DRAINAGE LETTER

WATER TREATMENT PLANT BUILDING ADDITION

SECURITY WATER DISTRICT

PROJECT NO. 2022-076.130

APPENDIX G – BIORETENTION POND SIZING

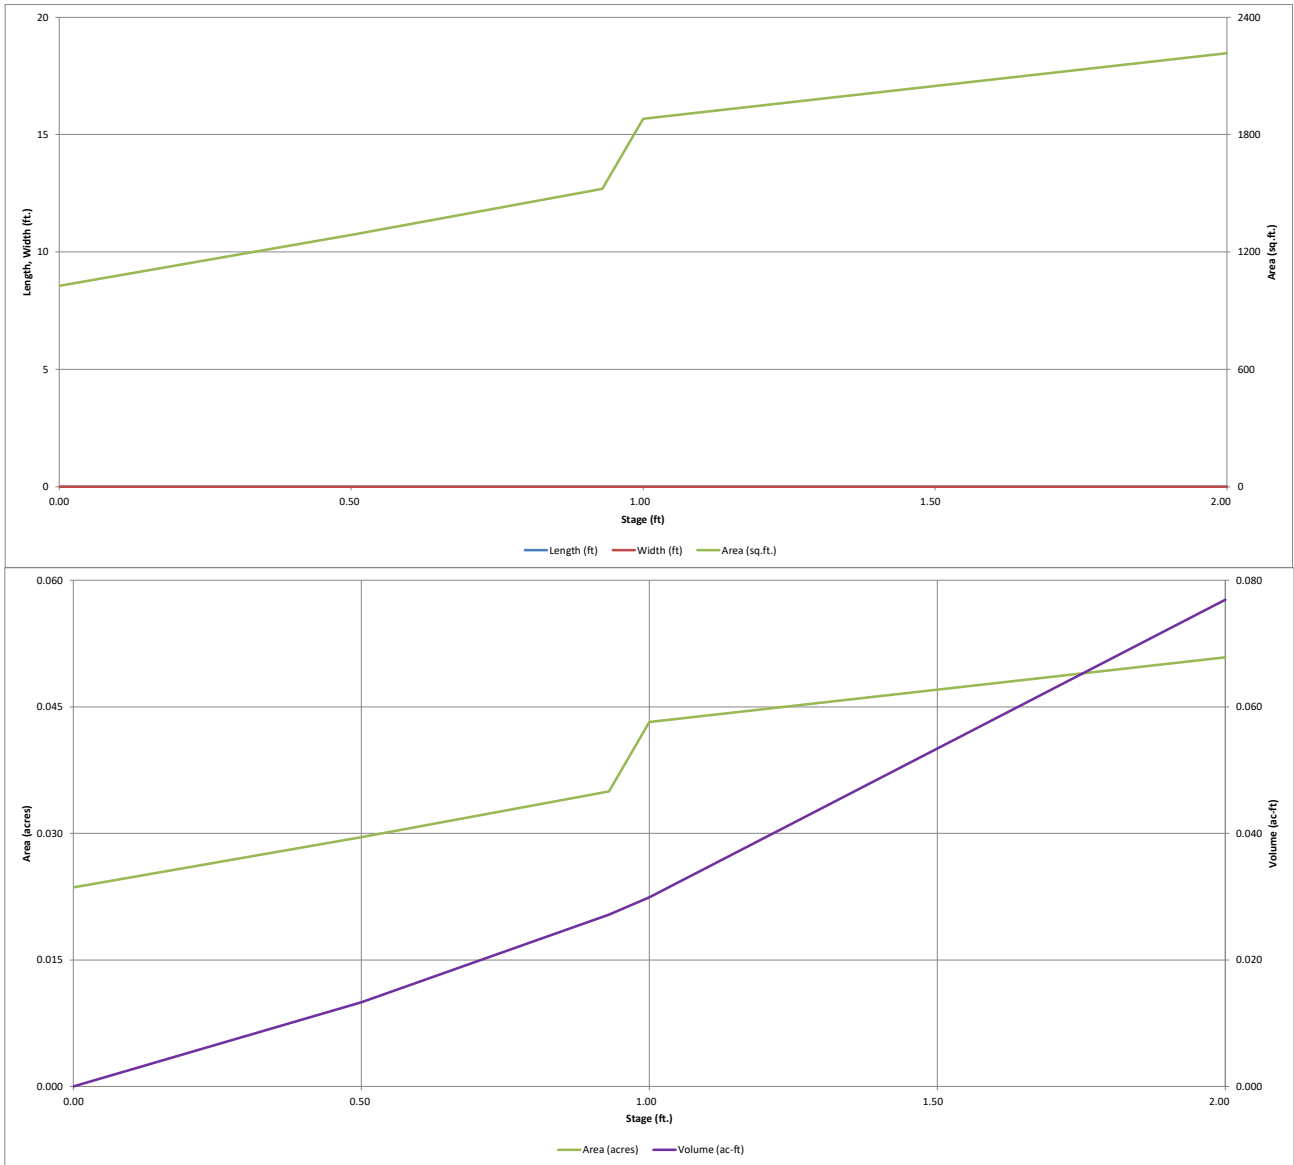
Plans unclear. See comments in site dev plan

Plans show 4:1
